**Final Drainage Report
The Glen at Widefield Filing No. 12
El Paso County, Colorado**

Kiowa Project No. 19016

April 13, 2023

IRF Zones A & B (UIA/RPA)
IRF UD_BMP Spreadsheet Results

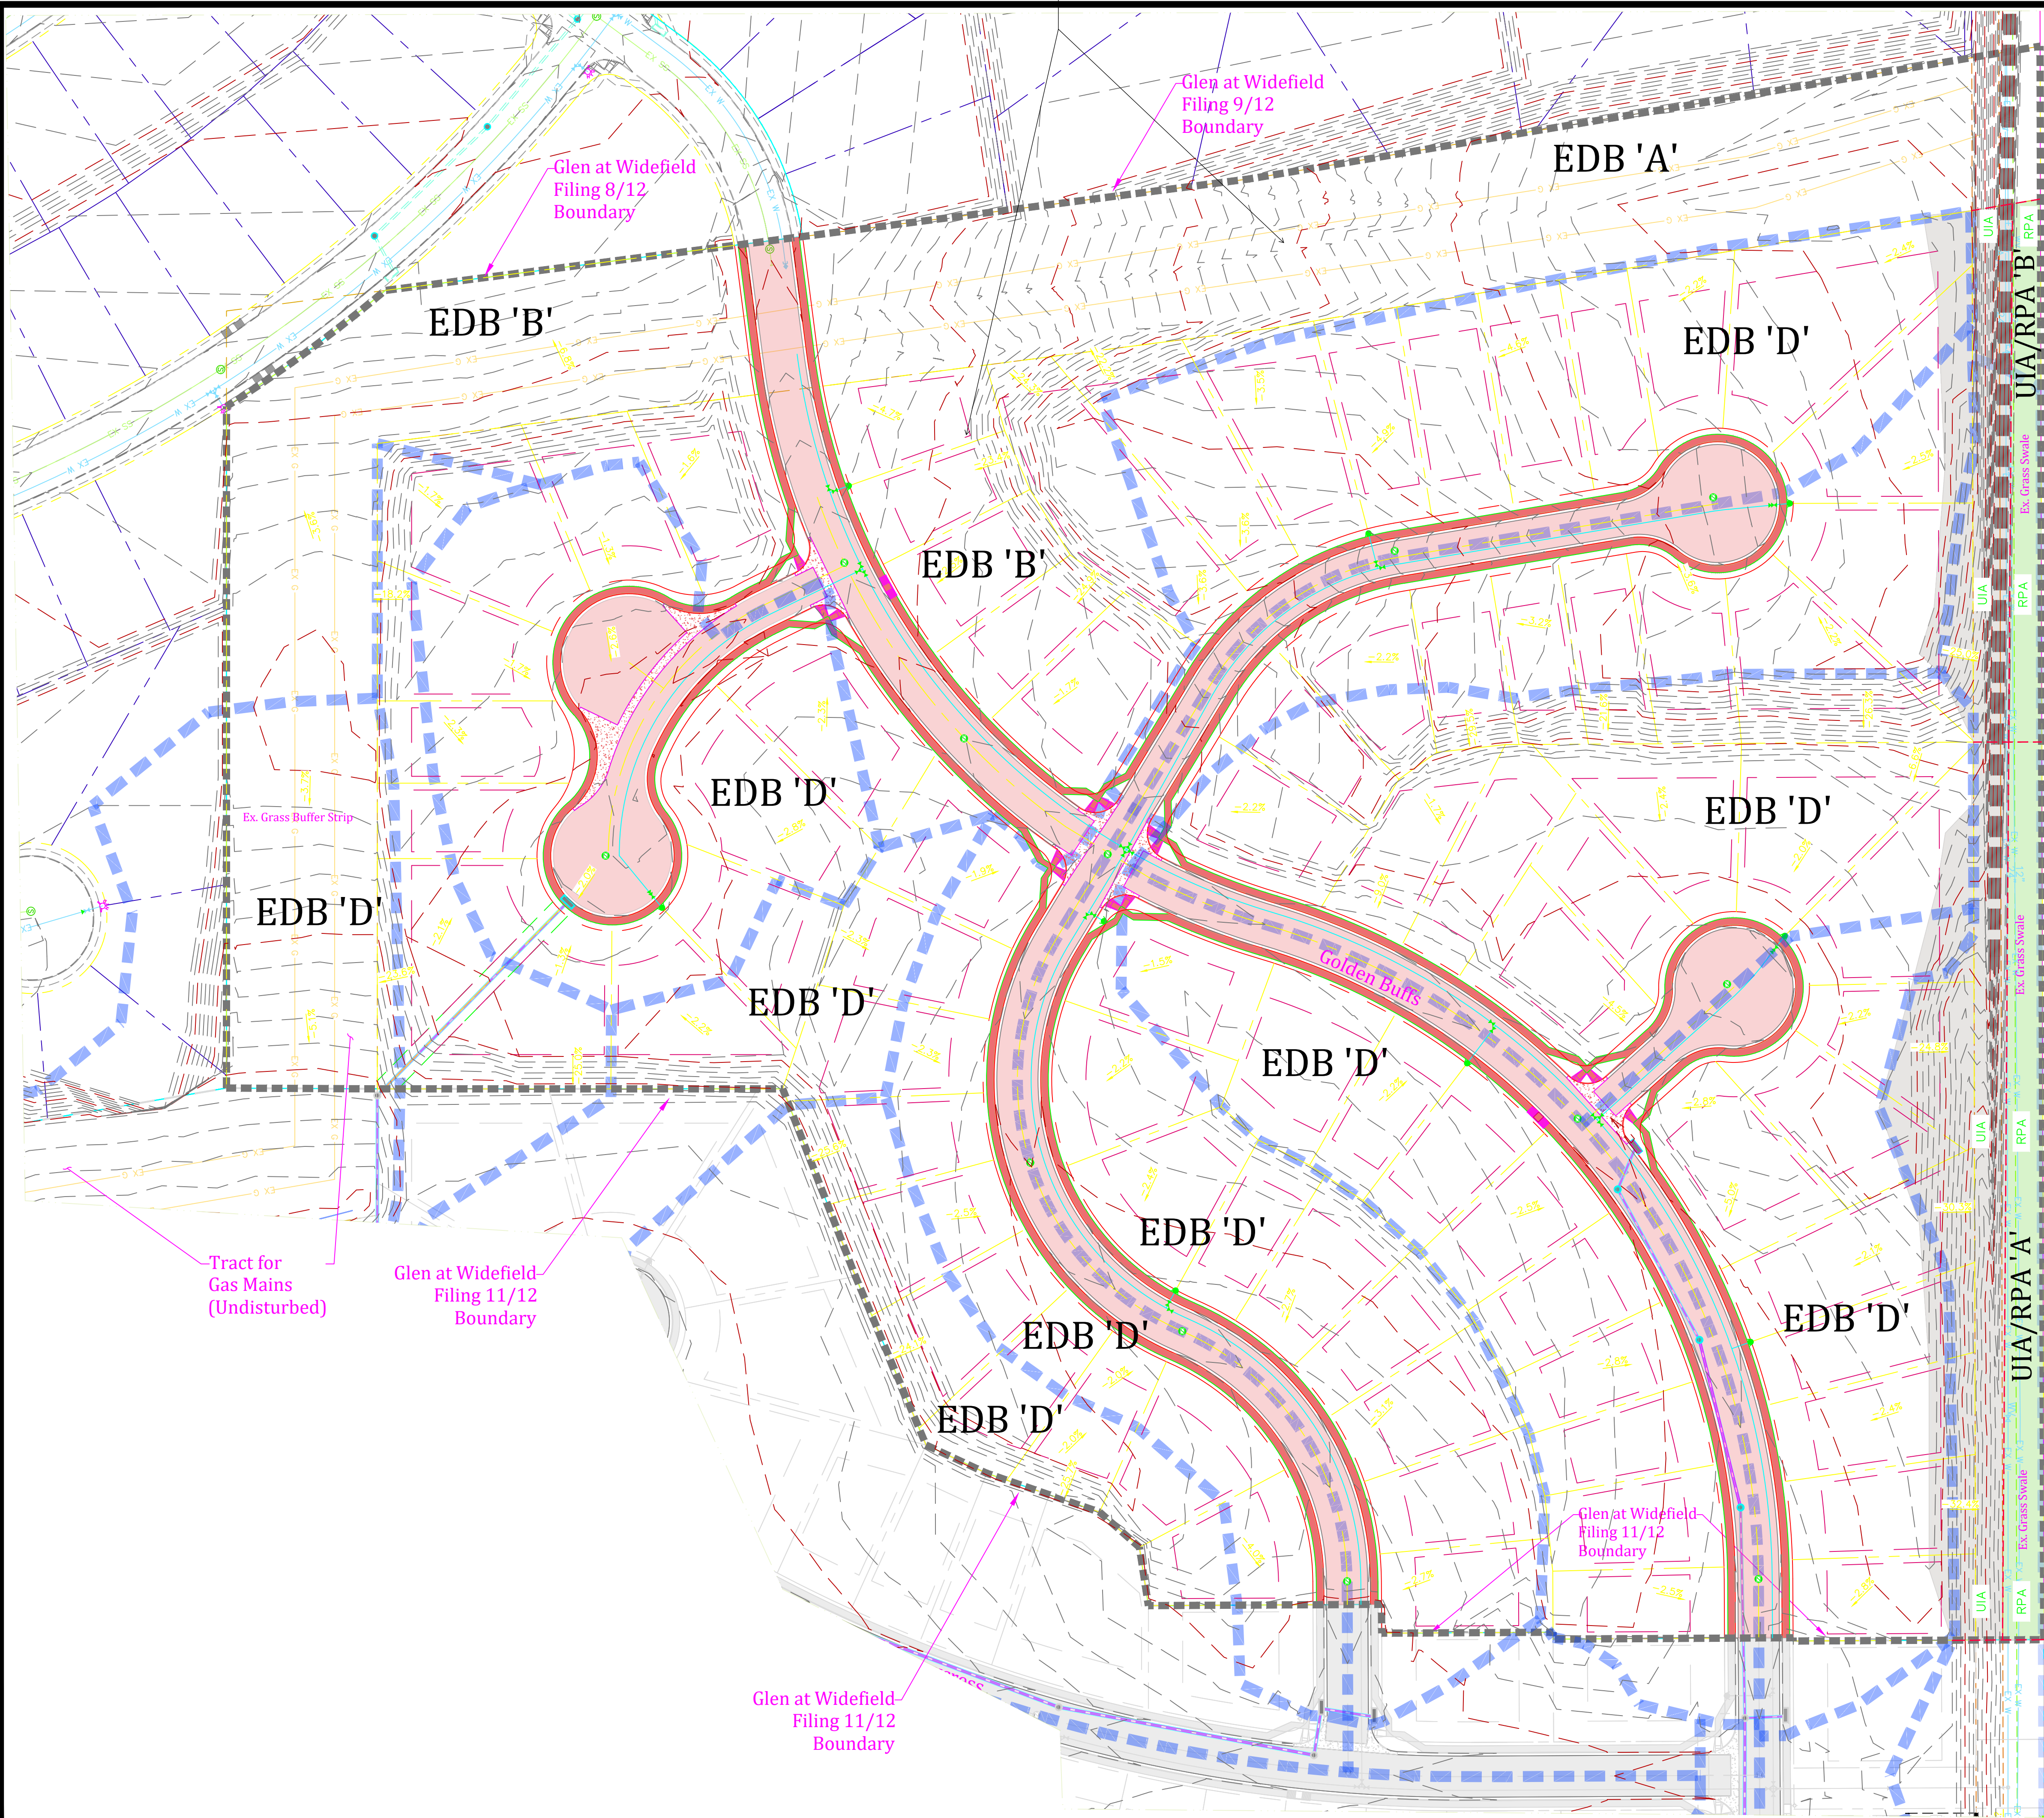
add boundary to separate EDB A and EDB B
